An Bord Pleanála Oral Hearing

Greater Dublin Drainage

Response to Inspector's Questions

Marine Water Quality – Alan Berry

Figure 8.6: Calibration locations

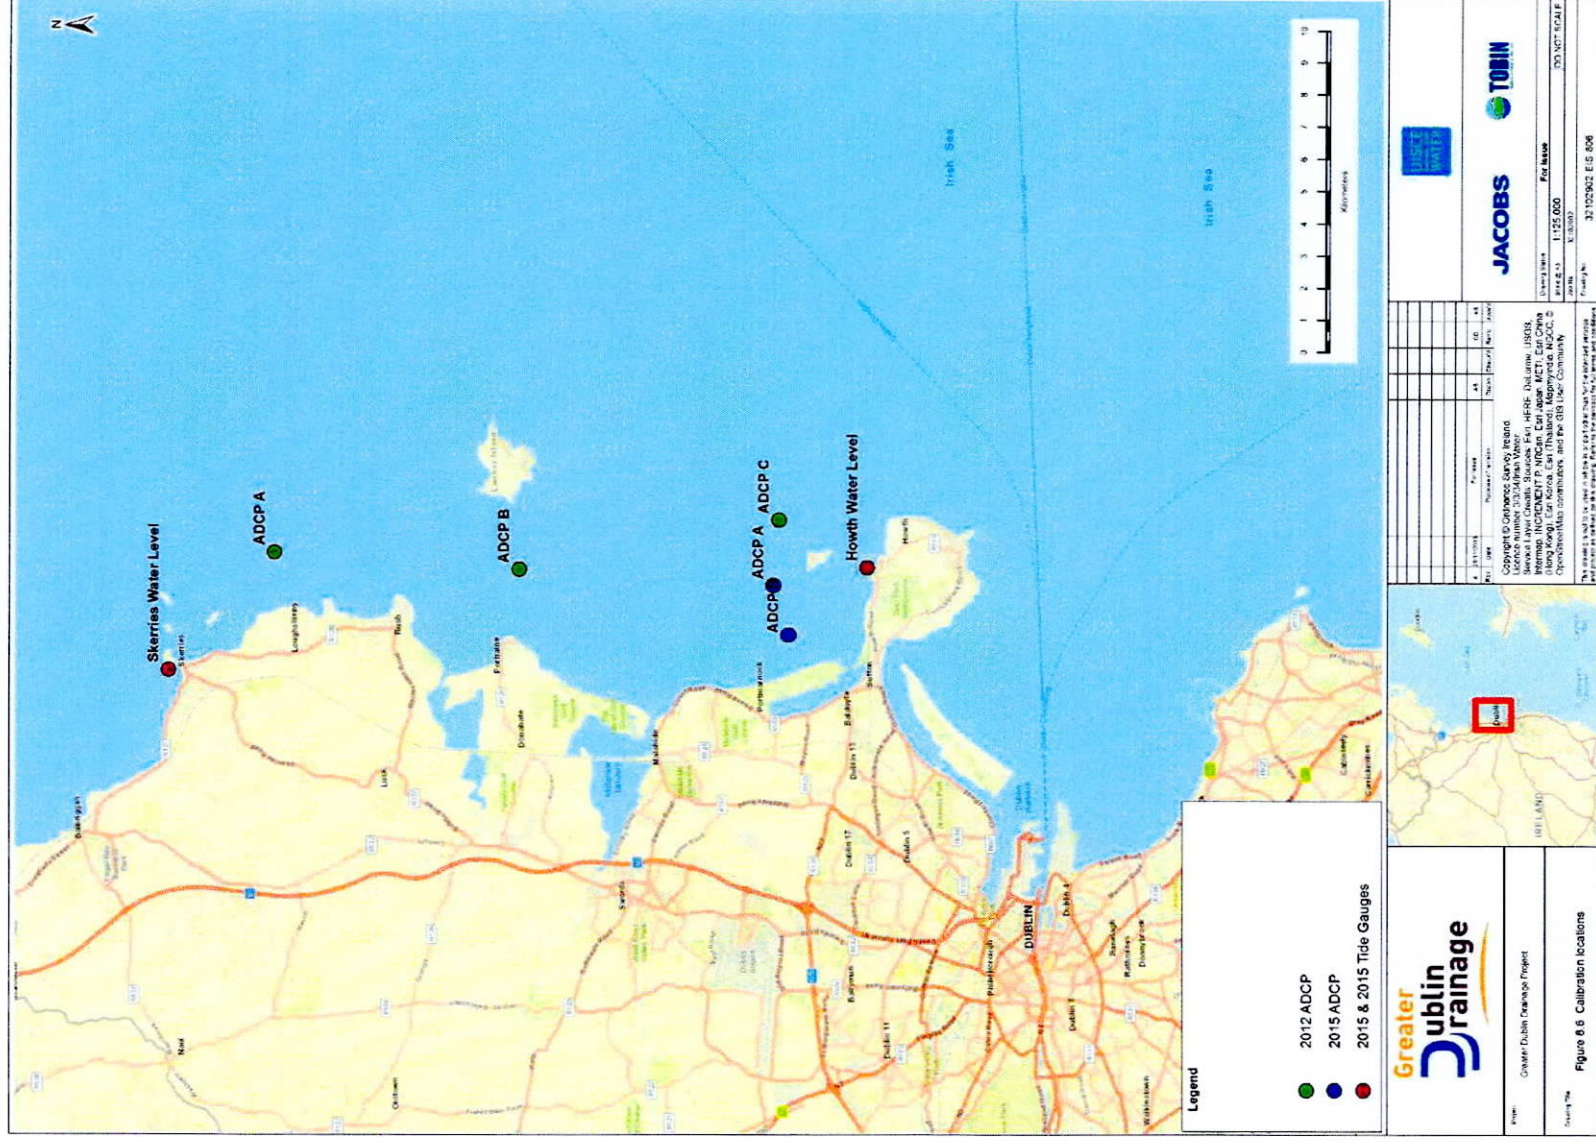
- 16 Could Mr. Berry address the issue of errors in modelling and what is meant by 'excellent' and 'good.'

- 32 Modelled tidal levels were compared against measured data at both the Skerries and Howth tide gauge locations in order to provide a quantitative assessment of inaccuracies in tidal characterisation.

- 33 Modelled current speeds and directions were compared against measured data at the ADCP locations A, B and C in order to provide a quantitative assessment of inaccuracies in tidal characterisation.
- 34 In order to quantify model calibration, a series of quantitative statistics have been calculated to compare water levels, current speeds and directions. The statistical assessment includes the derivation of the metrics listed above. The results are presented in Table 8.4 and Table 8.5 of the EIAR with **PASS** and **FAIL** of the above metrics highlighted where applicable.

- 36 In general, the comparison of the modelled and measured datasets, both statistically and visually, demonstrates a robust calibration agreement. Overall, Table 3 shows that the model is providing an 'excellent' representation of water levels and, generally, between a 'good' and 'reasonable' representation of current speeds and directions at the ADCP locations.
- 37 It is noted that the calibration of the model was 'good' at ADCP C location (the location of the proposed GDD marine outfall).
- 38 The summary of results presented above show that the numerical model has been successfully calibrated and validated against field measurements, to provide a sufficiently accurate representation of the hydrodynamics within the study region.
